IN THE SPECIFICATION

Please accept the following amendments to the specification:

[Chemical Formula 7]

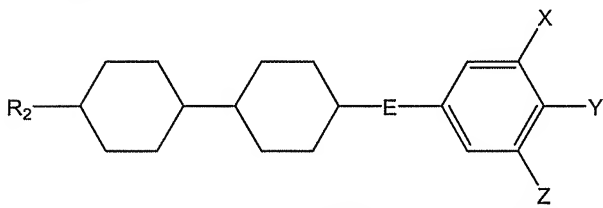
The following structures replace those for chemical formulas 7 and 8 on page 15, lines 10 to 13:
